PLANNING COMMITTEE 3 September 2018

SUMMARY OF ADDITIONAL CORRESPONDENCE RECEIVED SINCE THE PUBLICATION OF THE AGENDA AND ERRATA

18/01053/F Adj Lime Kiln Cottages Cuckstool Lane Castle Acre

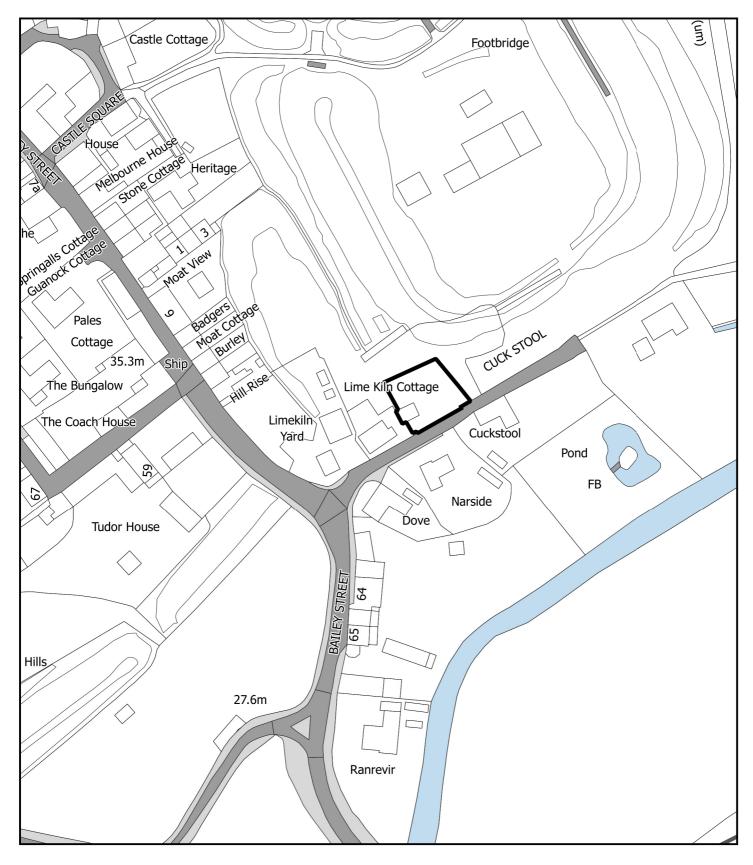
- Page 42 of the full agenda presents the plan 18/01053/F, which turned out to be somewhat contentious and which shows a turning bay to the east of the proposed property. Subsequently there have been two amended plans and revisions made by the agent. Do we assume that these new drawings and new plans which are preferred by both Cuckstool Cottage, and I believe, Lime Kiln Cottage, are the ones on which any planning decision will be made?

In regards to the incorrect map published on Page 42 of the Agenda, please see the amended map that accompanies this summary of late correspondence.
